Ameren Missouri Response to NRC RAIs

On March 31, 2021, Union Electric Company, dba Ameren Missouri, submitted a license amendment request (LAR), in combination with a request for regulatory exemptions, for adopting a risk-informed approach for resolving GSI-191 and responding to Generic Letter (GL) 2004-02, for Callaway Plant. In support of the initial submittal, a number of supplements have been submitted, as identified in the cover letter of this submittal. As the U.S. Nuclear Regulatory Commission (NRC) staff is continuing to review the application, it recently determined that additional information is required in order to complete the review of the subject LAR. The NRC staff's request for additional information (RAI), consisting of two individual requests, RAI No. 1 (with two parts) and RAI No. 2, was electronically transmitted on April 5, 2022.

Figure RAI-1.1. First view of Callaway fiber insulation (Nukon™ in gold, ThermalWrap™ in tan).

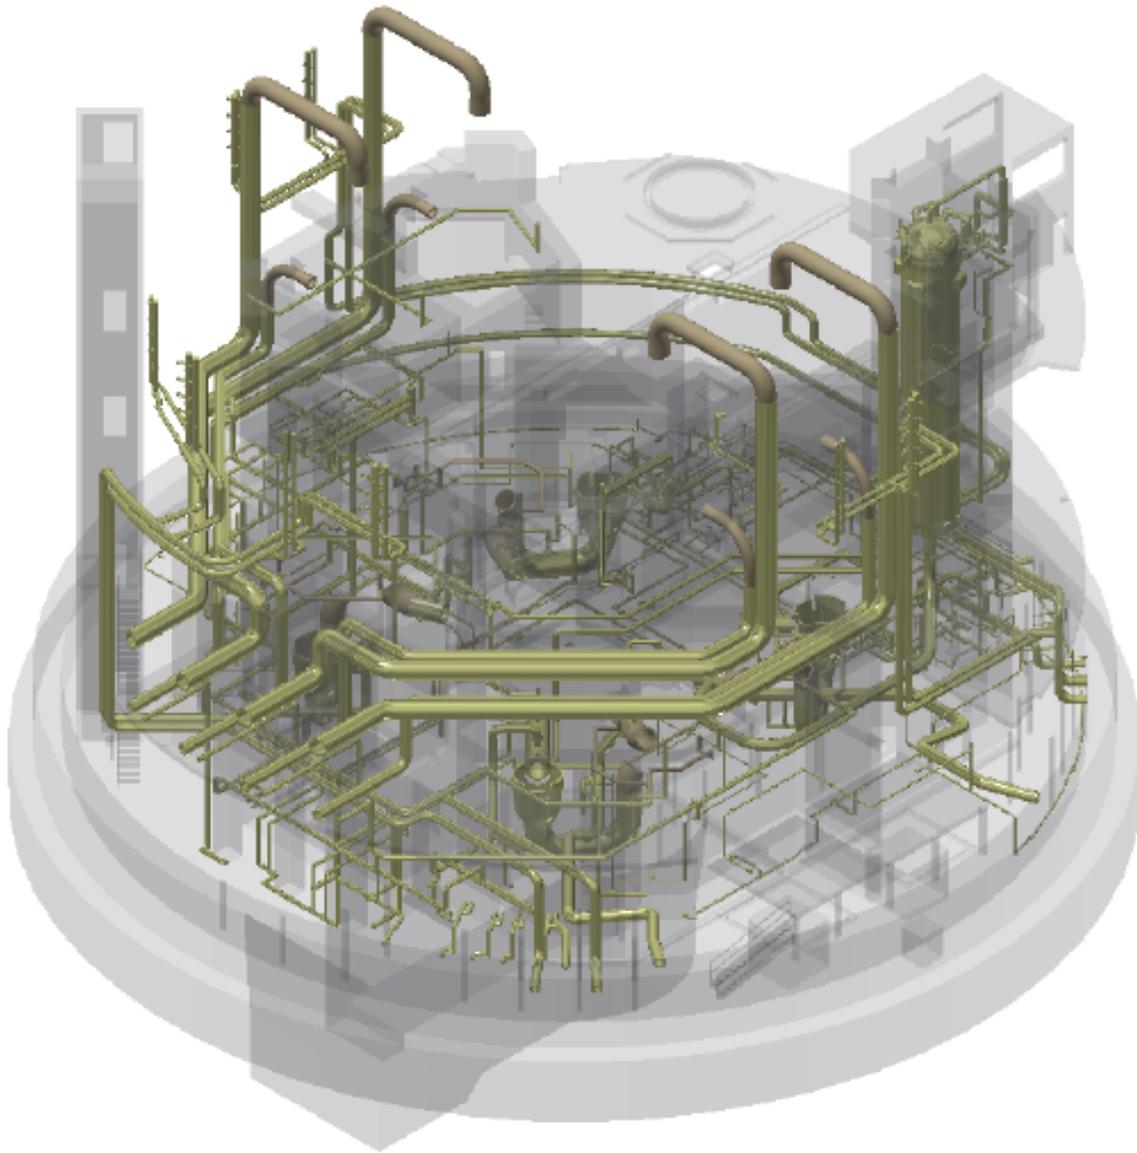
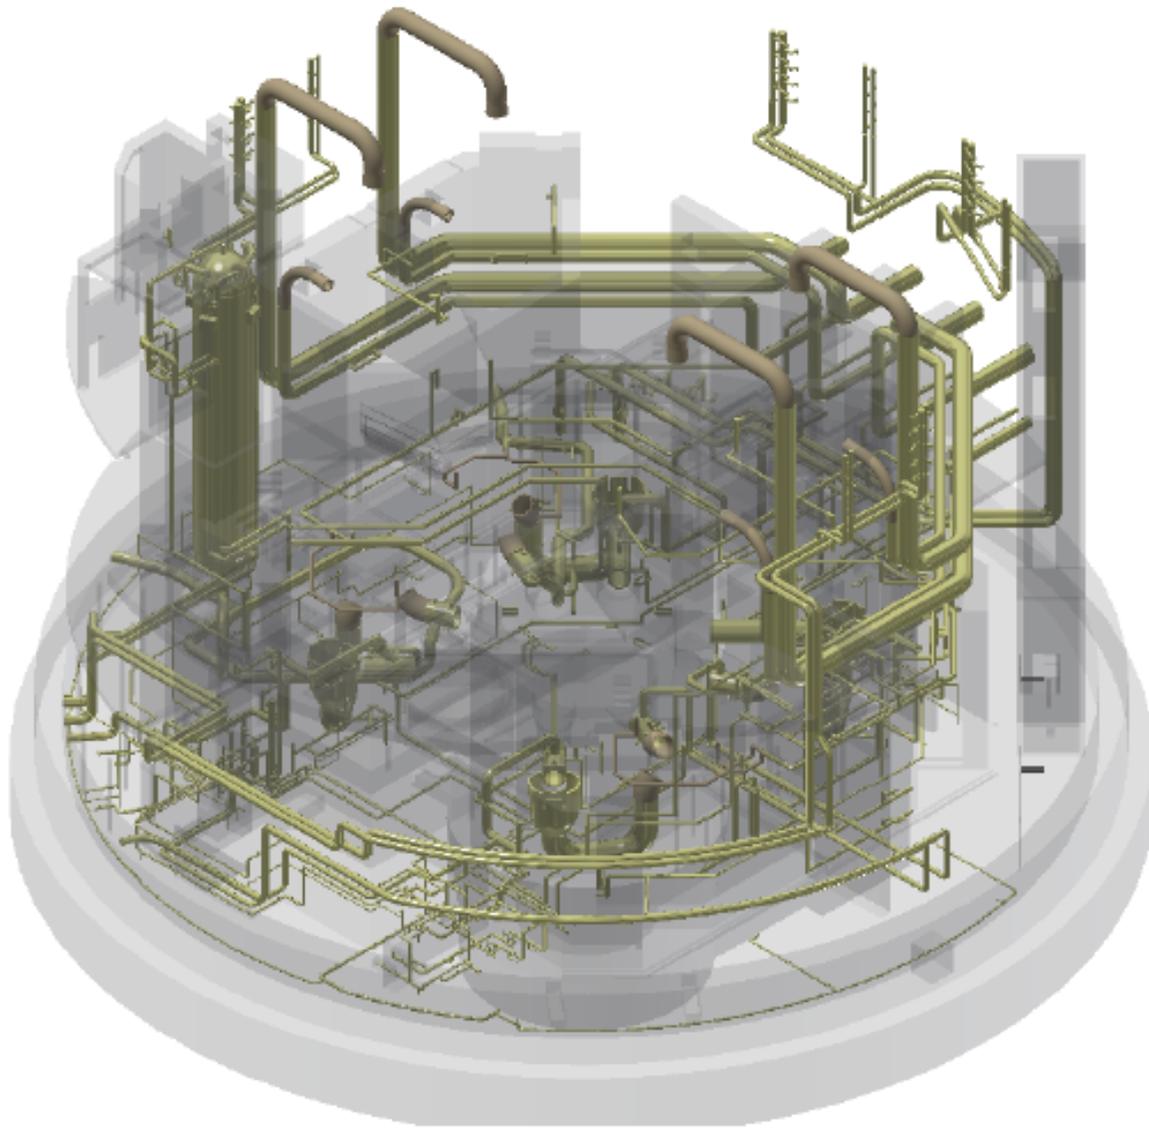
b) Enclosure 1 also states that compliance with 10 CFR 50.46(a)(1) and the relevant General Design Criteria would entail removal and disposal of significant amounts of insulation. In order to support the staff's evaluation of potential waste management impacts, NRC requests that Ameren Missouri provide the estimated volume (cubic feet) of radiologically contaminated waste that would be generated from the replacement of the existing insulation addressed in Enclosure 1.

- b) Figures RAI-1.1 and RAI-1.2 (on the following pages) illustrate the low-density fiber glass (LDFG) insulation present in the Callaway containment building. Gold-colored jackets denote Nukon™ insulation, and tan-colored jackets denote ThermalWrap™ insulation (mostly applied to top segments of the Main Steam and Feedwater lines). These images are produced from the CAD model used/described in Enclosure 1 to the March 31, 2021 LAR (identified above and as Ref. RAI-1.3 on page 4) to address the "RoverD" risk attributed to fiber insulation. The figures illustrate that fiber insulation is present in every region of containment, including locations difficult to access that would prolong worker exposure and high-dose areas such as the Regenerative Heat Exchanger and the Letdown Valve Cubicles that are presently managed as locked high-radiation areas.

There are 5023.5 ft³ of Nukon™ and 436.1 ft³ of ThermalWrap™ in containment, giving a total LDFG inventory of approximately 5460 ft³. Assuming a manufactured density of 2.4 lbm/ft³, this volume corresponds to a total potential debris mass of 13,103 lbm, or 6.6 tons. Most of the removed insulation would be disposed of as low-level radioactive waste with varying degrees of radiation contamination and associated hazards.

Figure RAI-2.1. Containment-pressure-available history for LBLOCA.

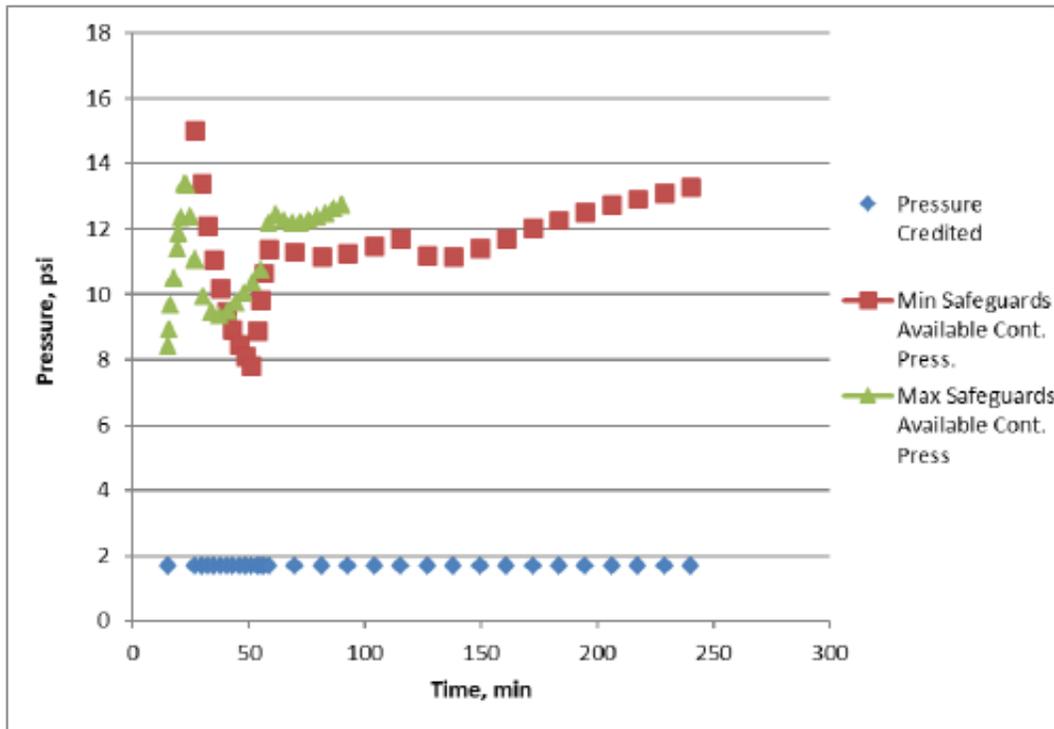
Request: Clarify whether the 10 percent value is based on the time at which the minimum margin to flashing occurs and that it is based on the pressure predictions for the LBLOCA, not the [main steam line break](#). If it is not based on the time of minimum margin, provide the margin to flashing based on the time at which the margin to flashing is at its minimum.

Figure RAI-2.1 (next page) displays containment pressure available for a LBLOCA with minimum and maximum safeguards configurations from the time of ECCS switchover until the time when sump temperature reduces below 212 °F. Containment pressure available equals calculated absolute containment pressure reduced by saturation pressure and reduced by an additional 1.8 psi. Saturation pressure is required to maintain the fluid as a liquid, and thus, it is not available for containment overpressure credit. The further reduction of 1.8 psi is determined by reducing the calculated containment pressure of the design basis analysis from a Technical Specification maximum of 1.5 psig [References RAI-2.1 and RAI-2.2 on page 9] to the Technical Specification minimum of -0.3 psig [Ref. RAI-2.1]. In the minimum safeguards configuration, available containment pressure reaches a minimum at approximately 50 min.

Figure RAI-2.1 illustrates that during most of the minimum safeguards LBLOCA history, 1.7 psi of overpressure credit is approximately 15% of containment pressure available ($1.7\text{psi}/11\text{psi} \approx 15\%$). For approximately 30 minutes, 1.7 psi is more than 15% of the available containment pressure and reaches a maximum credit of approximately 22% at the minimum-safeguards-LBLOCA minimum available containment pressure ($1.7\text{psi}/7.7\text{psi} \approx 22\%$). When consideration is given to pump flow timing, required overpressure is reduced to approximately 10%, or less, of available containment pressure for the duration of the accident scenario (presented below).
